# United States Department of the Interior

BUREAU OF LAND MANAGEMENT

Re: Resource Recovery and Protection Plan (R2P2) Minor Modification, Centennial and  
 Aberdeen Seams' Longwall Mining Plans

# TOWER DIVISION CENTENNIAL SEAM PRODUCTION AREAS LONGWALL PLAN

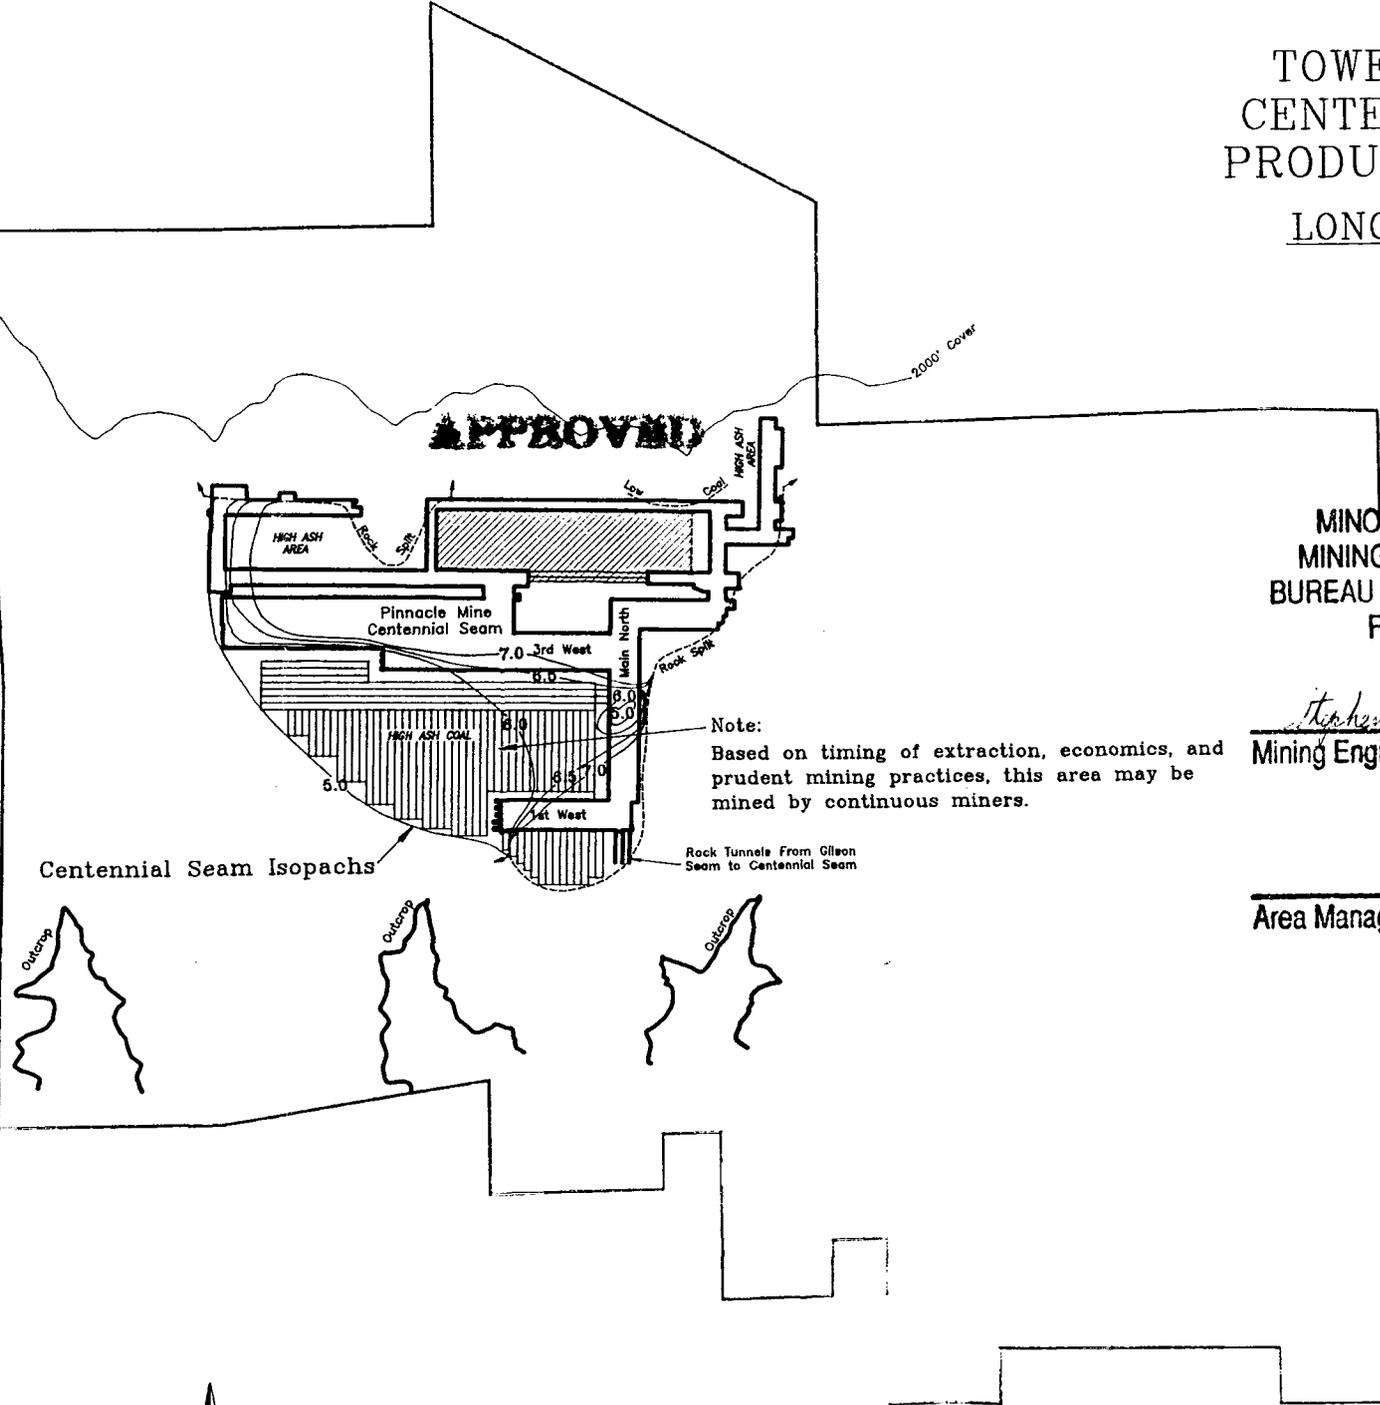
The mining efforts to delineate the minable coal areas of the Centennial Seam have been witnessed by BLM inspectors over a period of two years. The location of the rock split that cut off development of the 4th West entries from the west was witnessed a number of times. The mining of 4th West from Main North (east to west) has also been witnessed a number of times. Low coal and an increase in rock bands in the coal were noted in the north-most entry of 4th West. The same rock split was noted in the west development of 4th West on

a recent inspection which completed the minable delineation of this panel. We agree that this one panel is feasible to mine and is blocked out along the edge of the rock split and thinning coal. Though the BLM had previously approved a change from longwall panels in the Centennial Seam to room-and-pillar panel, we agree that this latest change back to a longwall panel is due to a good delineation effort on the part of the continuous miner to explore the edge of the unminable coal. With the observed conditions, the one longwall panel (4th West) is the only minable block left in the north Centennial Seam.

The BLM has determined that the proposed modification complies with the Mineral Leasing Act of 1920, as amended, the regulations at 43 CFR 3480, the lease terms and conditions, and will achieve maximum economic recovery of the Federal coal. Andalex's revised plan for a longwall panel in the Centennial Seam and two extra longwall panels in the Aberdeen Seam is approved on condition. The two longwall panels in the Aberdeen Seam will be mined to the west limits of the minable coal as verified by BLM. A copy of the approved mine maps are enclosed.

TOWER  
 ABERDE  
 PRODUCTI  
 LONGWA

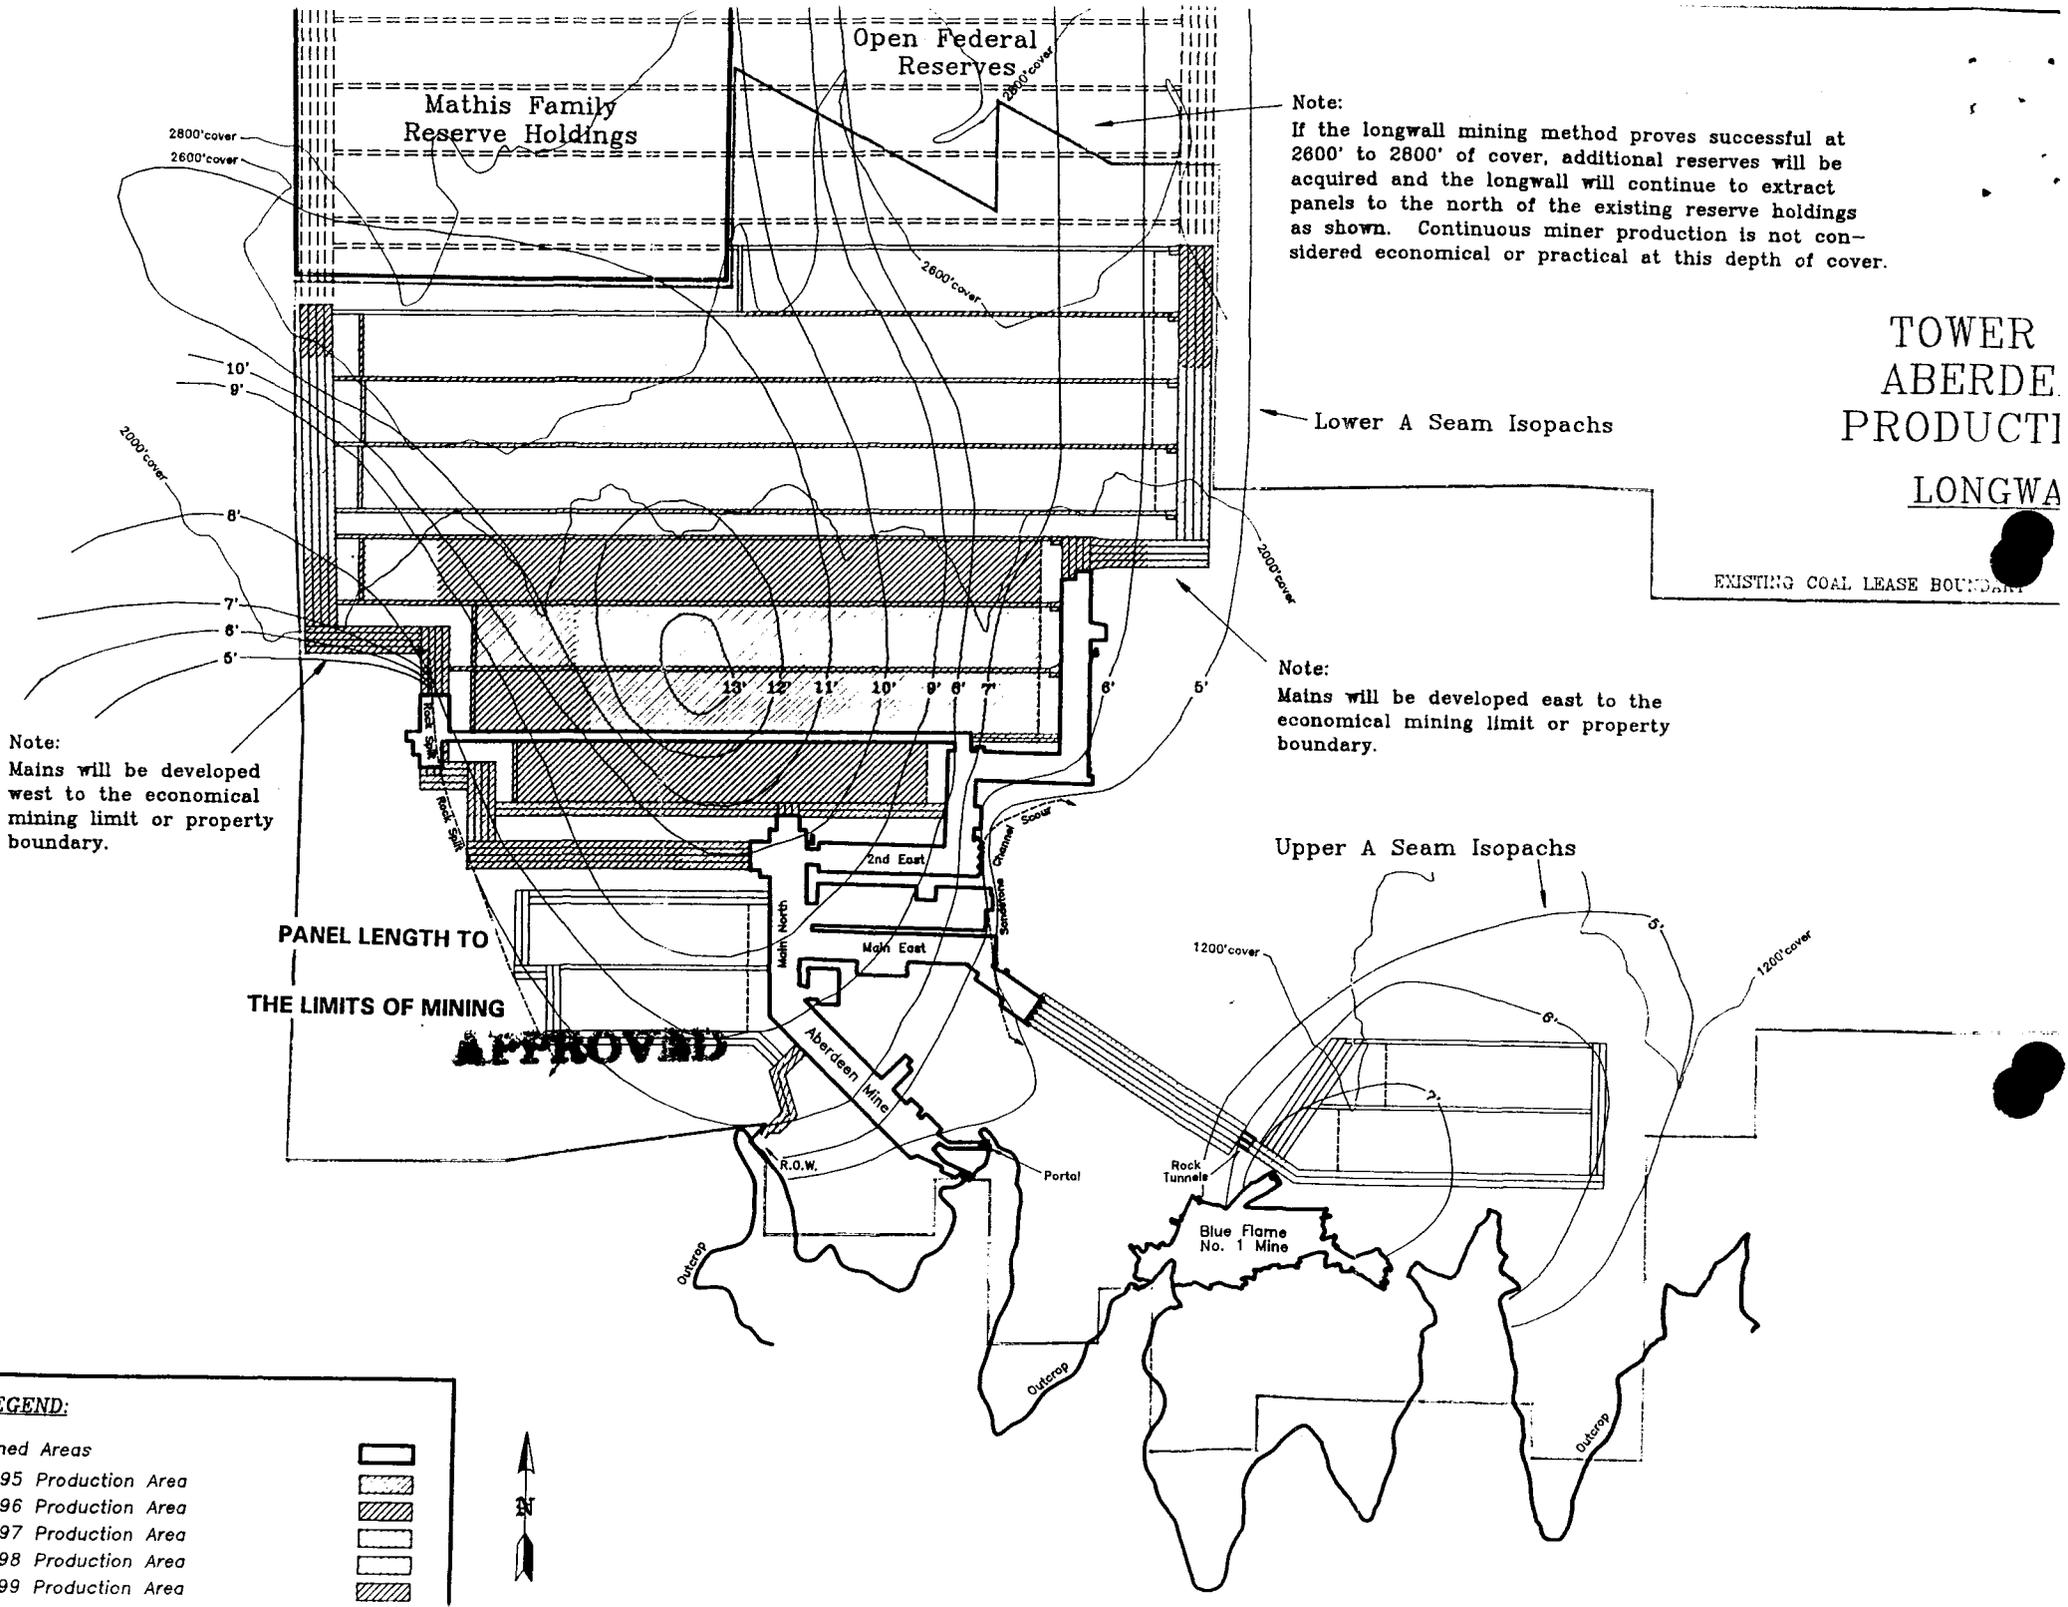
The two extra longwall panels proposed to be mined west off Main North in the Aberdeen Seam are in an area that has thinning coal to the west. Previous approved mining at the time of acquisition of lease area UTU-69600 called for room-and-pillar panels at the end of the mine life. The two longwall panels will fit well in this area and the BLM agrees that overall recovery of the block will increase with longwall mining.
